**THREE-SIXTEEN**

**QUAD-CITIES NUCLEAR STATION  
MISSISSIPPI RIVER**

A DEMONSTRATION TO THE UNITED  
STATES ENVIRONMENTAL PROTECTION AGENCY BY THE  
COMMONWEALTH EDISON COMPANY UNDER SECTIONS  
316a and b OF THE FEDERAL WATER POLLUTION  
CONTROL ACT FOR THE QUAD-CITIES NUCLEAR  
STATION AT CORDOVA, ILLINOIS ON THE  
MISSISSIPPI RIVER

## Errata

Figure 37. Rotifers as a percent of total zooplankton compared above and below Quad-Cities Station, January 1973 through July 1974.

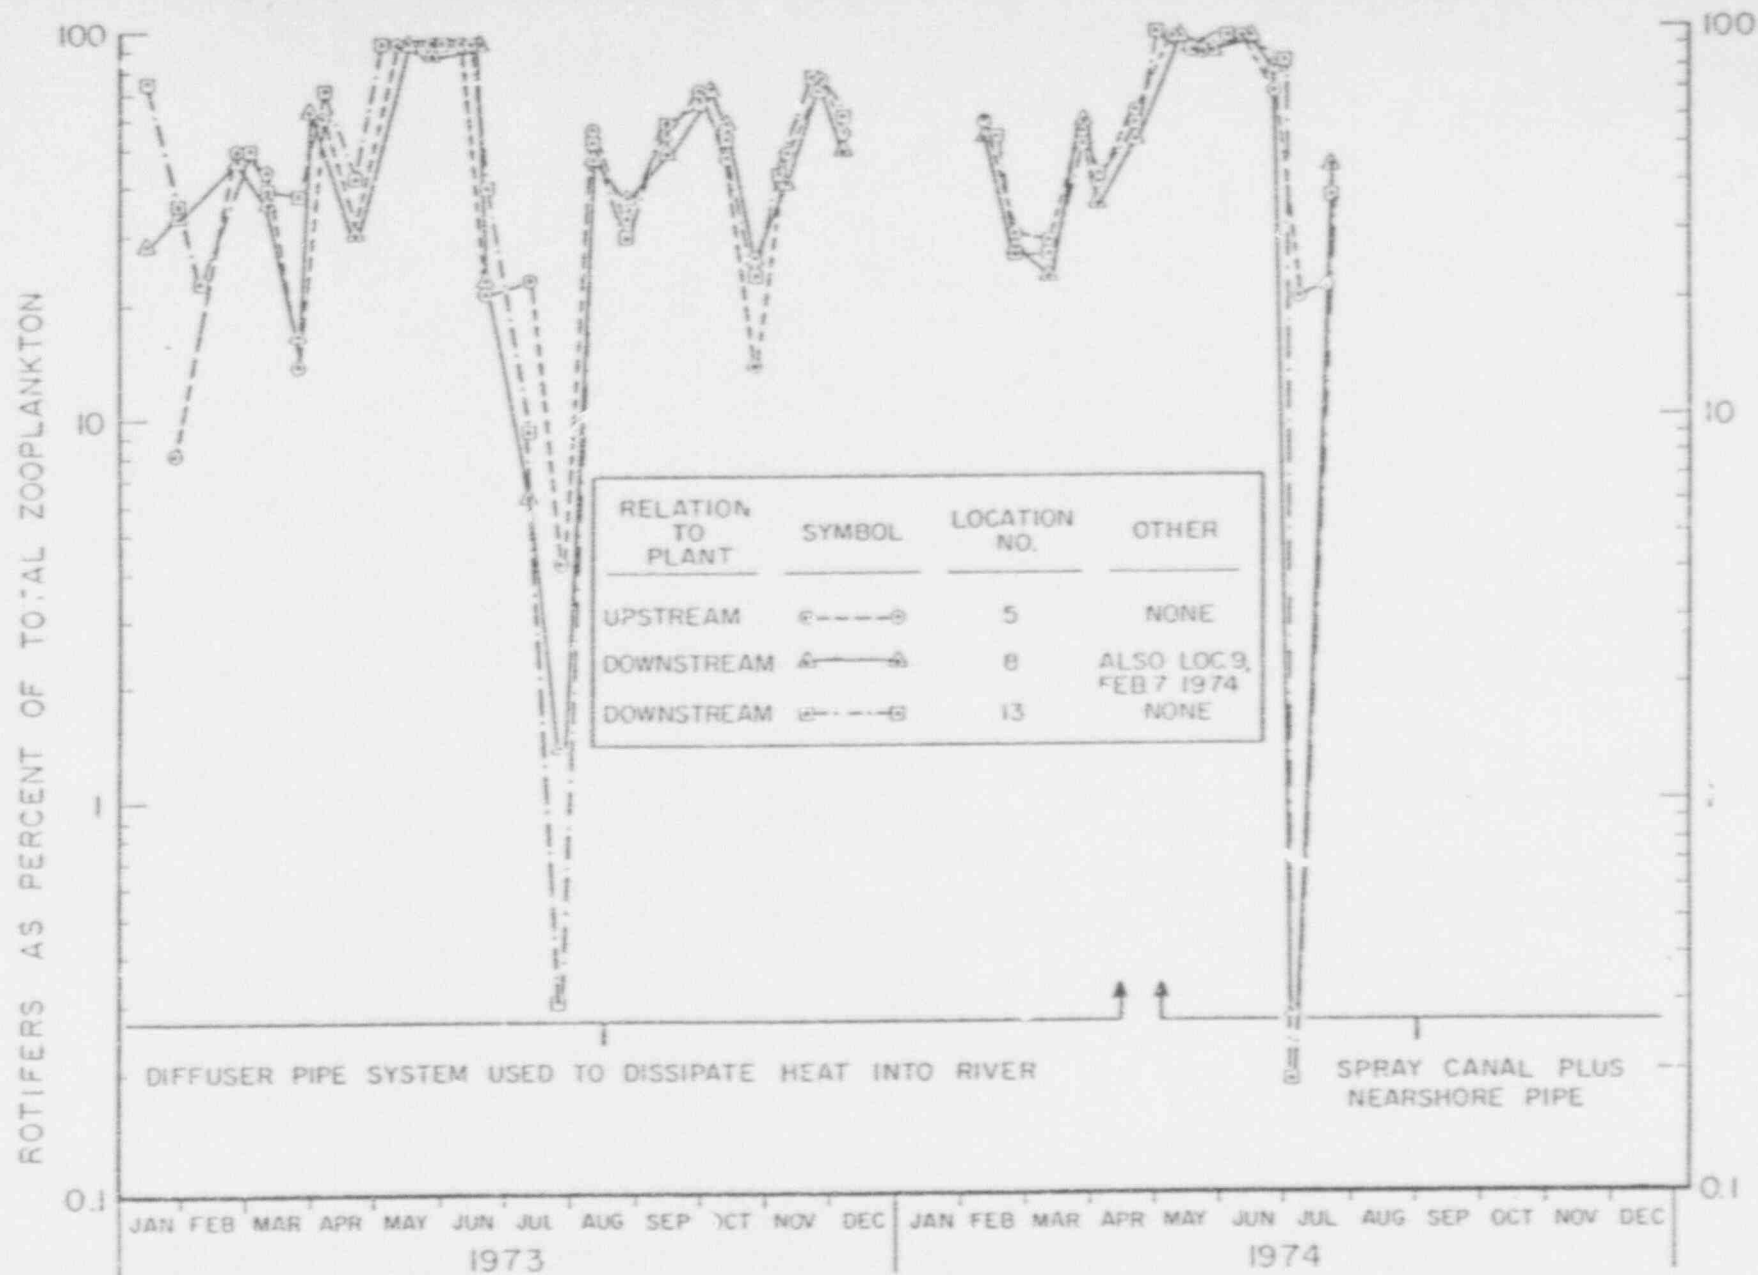
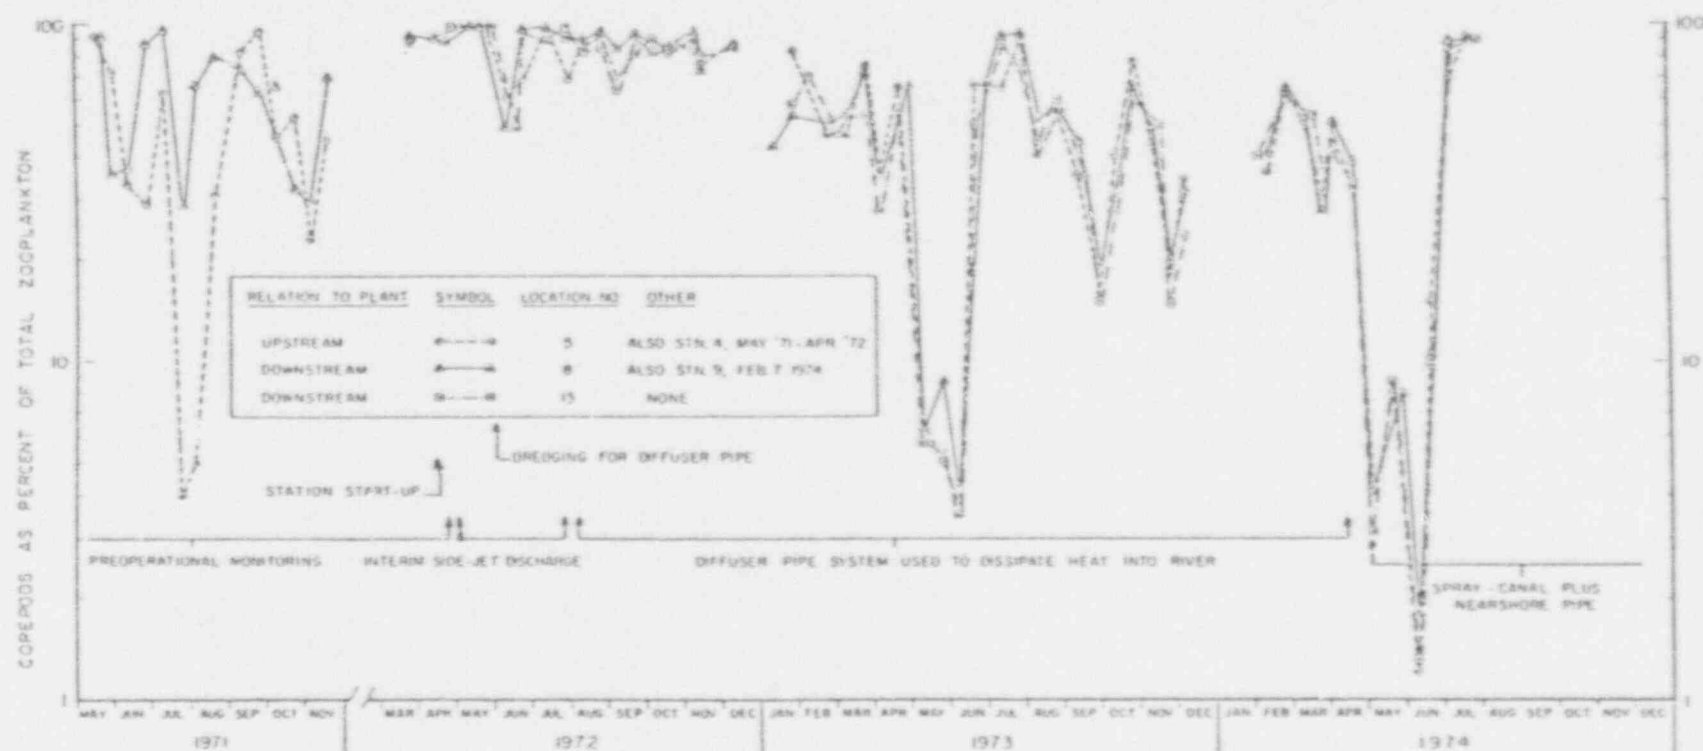
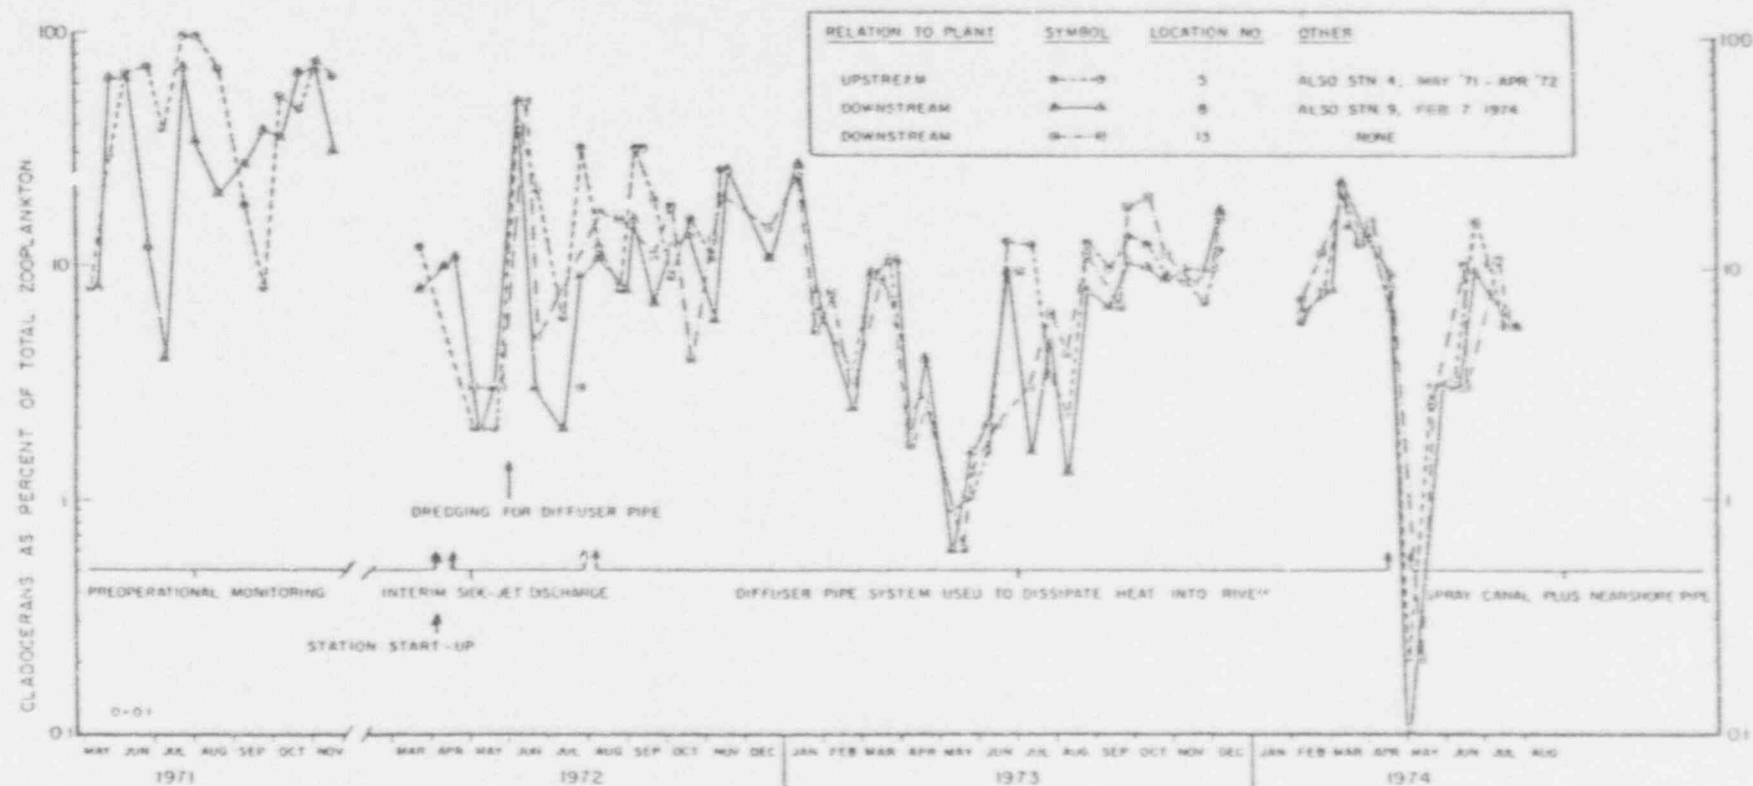
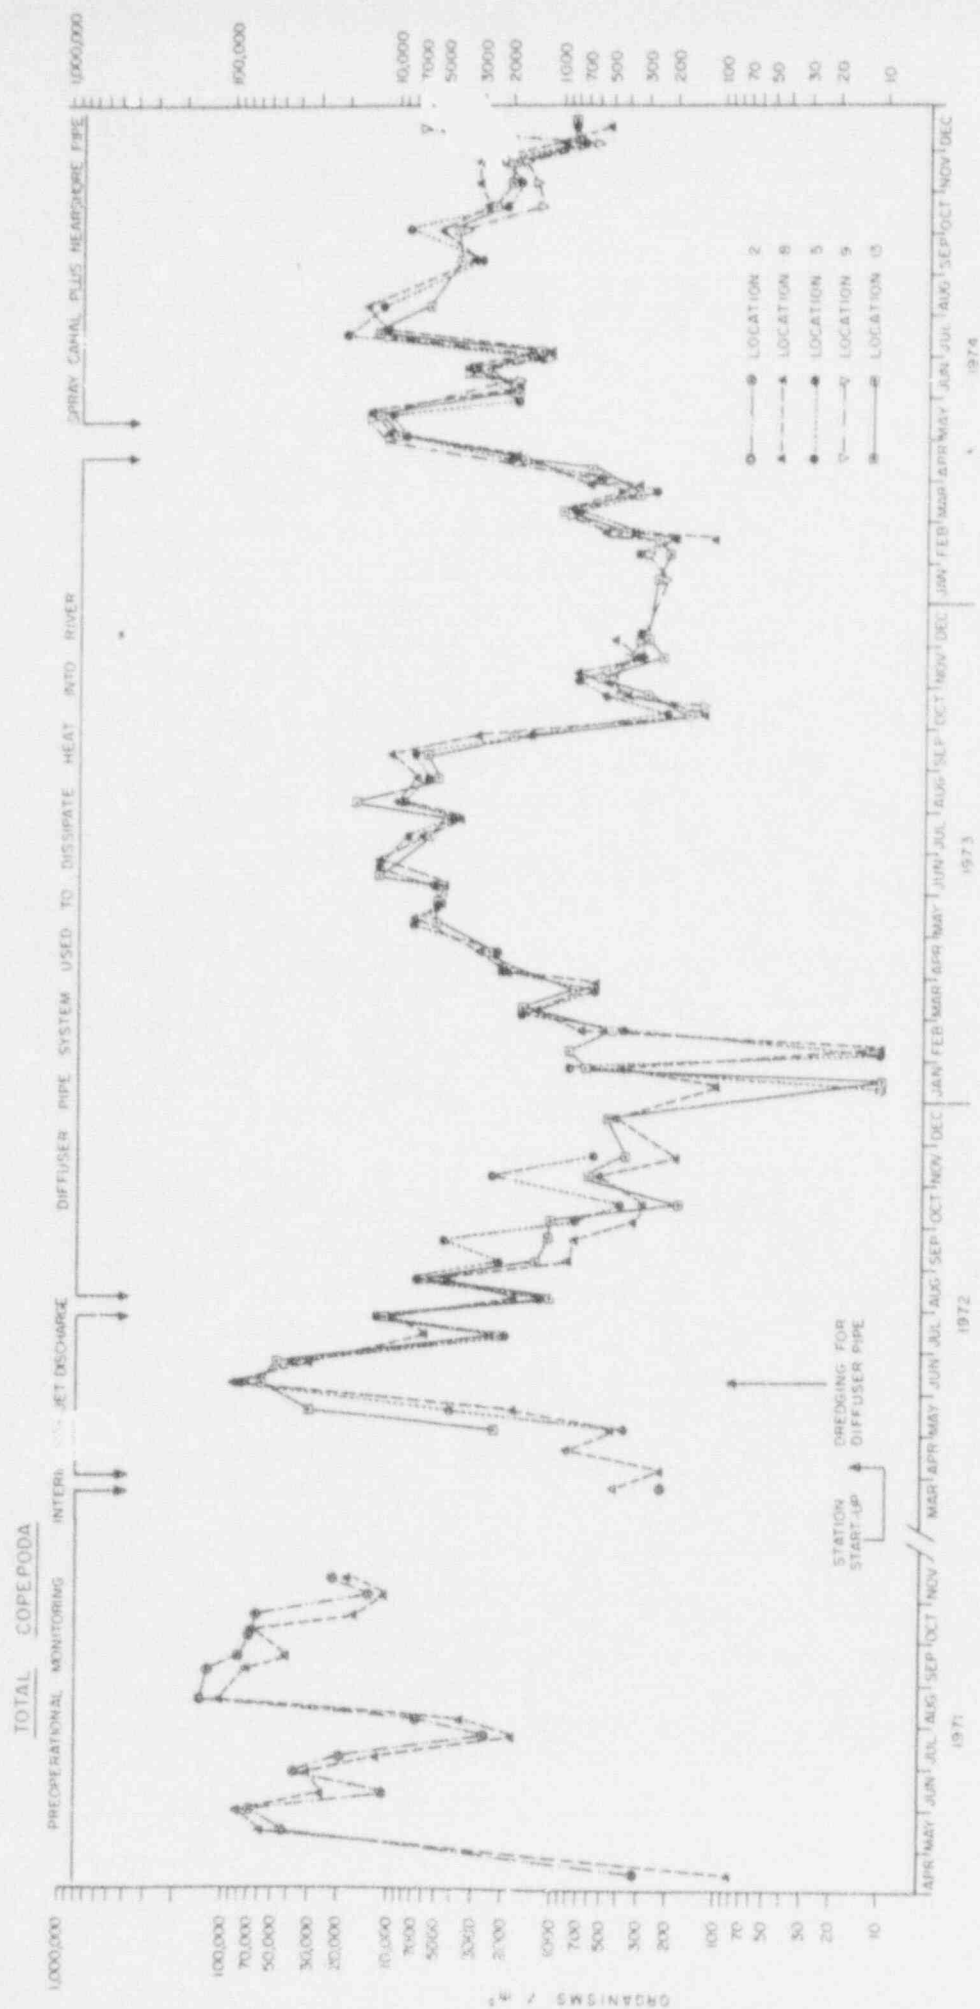
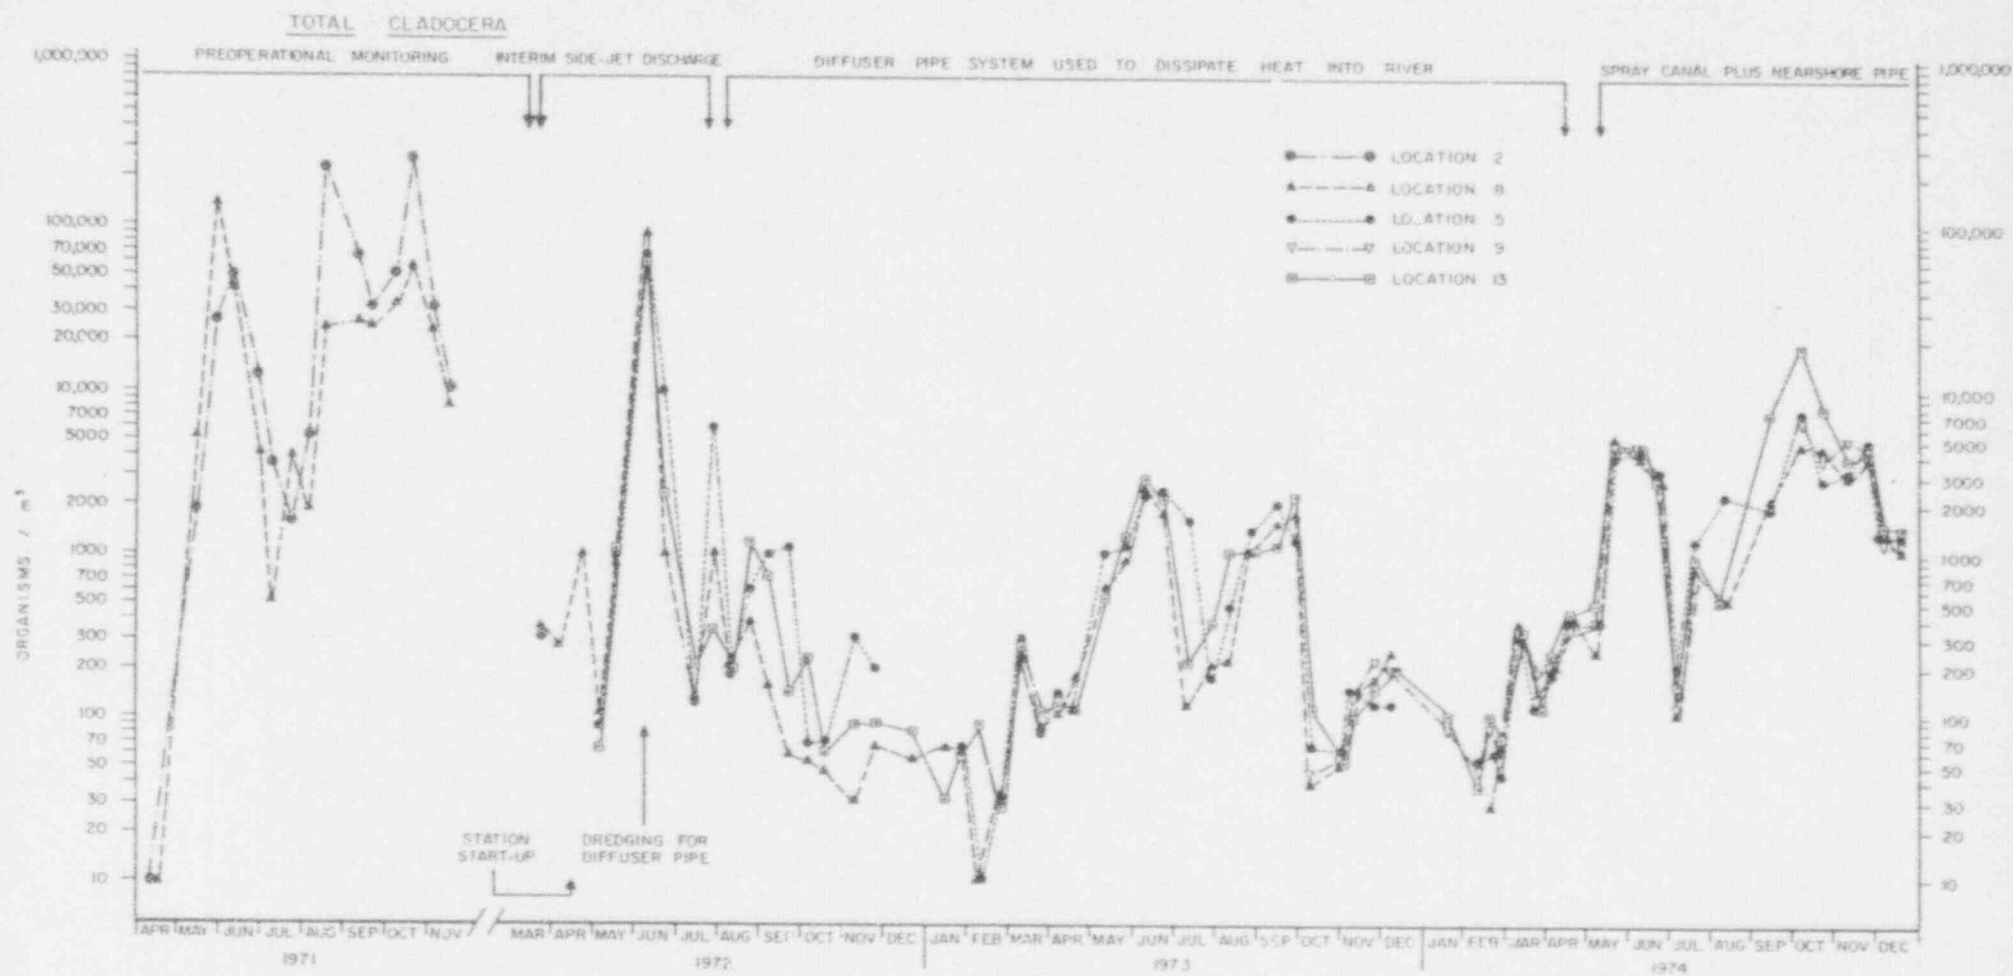
<u>PAGE</u>	<u>LINE</u>	<u>CHANGE</u>
150, 151, 152	Figures 37, 38, 39	Additional data is presented on the three major components of the zooplankton. However, the three curves that follow, (Figures 9.4, 9.5 and 9.6) taken from the latest semi-annual report are shown as numbers of organisms, rather than as percent of total zooplankton as was done originally for the 316a demonstration.
155	3	Eliminate quotation marks around the t
155	27	Change by to - bay
156	Figure 40	Original 316a graph is updated by page 345 (Figure 8.8) from the latest semi-annual report which follows this section but compares only upstream vs downstream. The original 316a Figure included a discharge bay station which was not a part of the river.
158	Figure 41	Original 316a graph is updated by page 344 (Figure 8.7) from the latest semi-annual report which follows this section but shows only the upstream/downstream comparisons. Additional periphyton data from the semi-annual report is also shown in forms not given in the original 316a demonstration: page 342, Figure 8.5 (periphyton biomass); and page 343, Figure 8.6 (periphyton biovolume).

Figure 9.4. Density of total Copepoda in the vicinity of the Quad-Cities Station, 1971-1974.

Figure 9.5: Density of total Cladocera in the vicinity of the Quad-Cities Station, 1971-1974.

Figure 9.6. Density of total Rotifera in the vicinity of the Quad-Cities Station, 1973-1974.
